P96-087 - O STREET DENTAL OFFICE

- REQUEST:
- A. Special Permit to allow one parallel parking space for a dental office in the C-2 (SPD) zone.
 - B. Variance to reduce the maneuvering area for three compact parking spaces from 19 feet to 17.5 feet and one standard parking space from 20 feet to 17.5 feet.
 - C. Variance to reduce the setback from 5 feet to 0 feet for a trash enclosure to service the office and residential units.
 - D. Lot Line Merger to merge two lots totaling 0.14± partially developed acres in the General Commercial Alhambra Special Planning District (C-2{SPD}) zone.

**NOTICE OF DECISION AND FINDINGS OF FACT FOR
(2801 O Street Dental Office), LOCATED AT 2801 O STREET
SACRAMENTO, CALIFORNIA IN THE
GENERAL COMMERCIAL (SPECIAL PLANNING DISTRICT) (C-2 (SPD) ZONE. (P96-087)**

Ⓑ NORTH ELEVATION
SCALE: 1/4" = 1'-0"

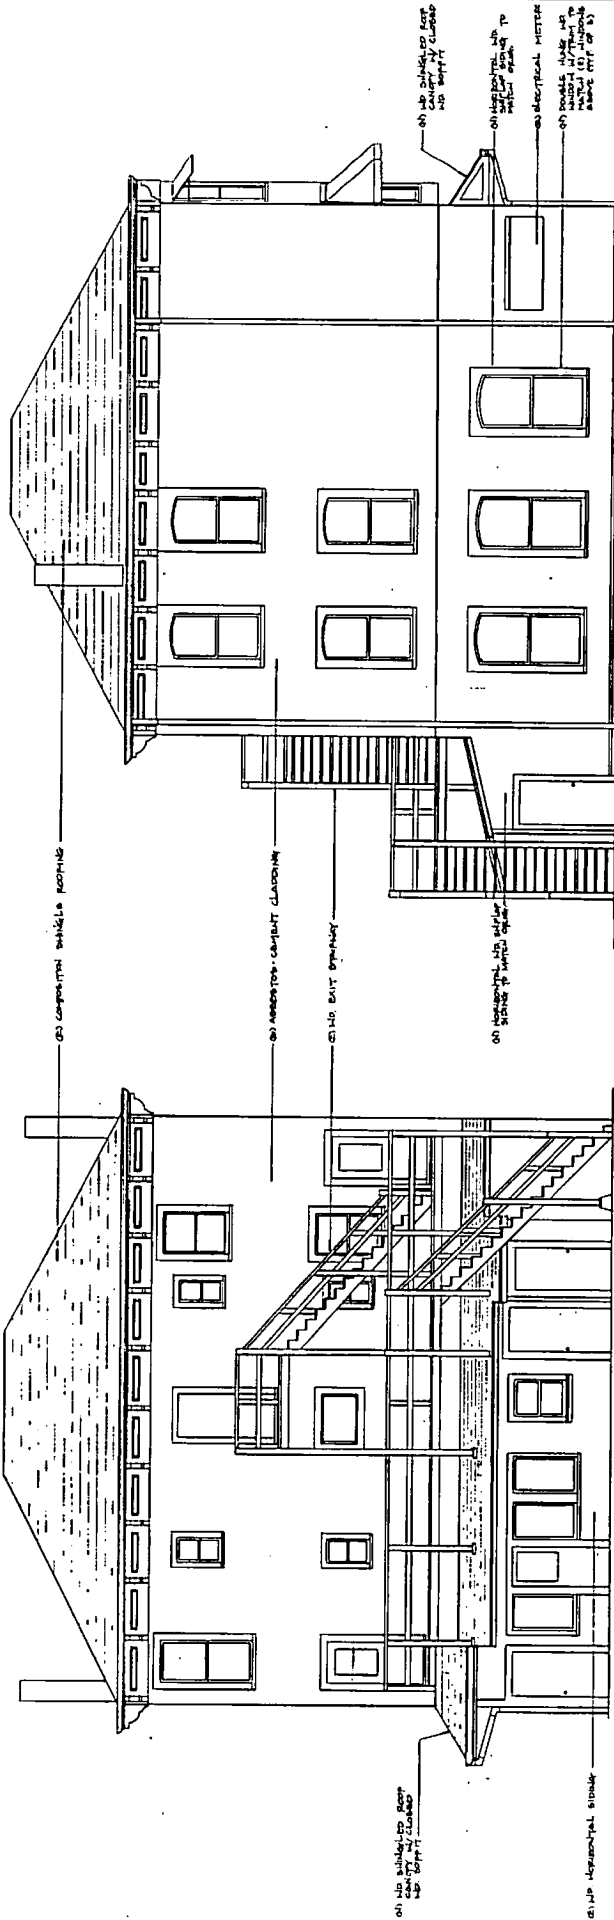
The existing 3 story building consist of horizontal wood siding and asbestos-cement cladding on the south, east and north elevations and above the first story on the west elevation. On the south elevation, a 1 to 1 1/2 foot brick accent is provided at the base of the structure. The first story, north, west and south elevations were modified at one time, with stucco replacing the shiplap siding and new windows replacing the double hung windows. The applicant proposes to replace the stucco on the west and north elevations with horizontal wood shiplap siding in keeping with the remainder of the building. The windows on the north, south and west will also be replaced with double hung windows in keeping with the remainder of the building. The brick accent at the base of the south elevation will be removed and replaced with horizontal shiplap siding.

A porch cover at the rear (east elevation) of the site will also be removed. A wood shingle roof canopy above the first floor is proposed on the east, south and west elevations. The canopy on the west and south elevations will overhang the public right-of-way and will require an encroachment permit from Public Works.
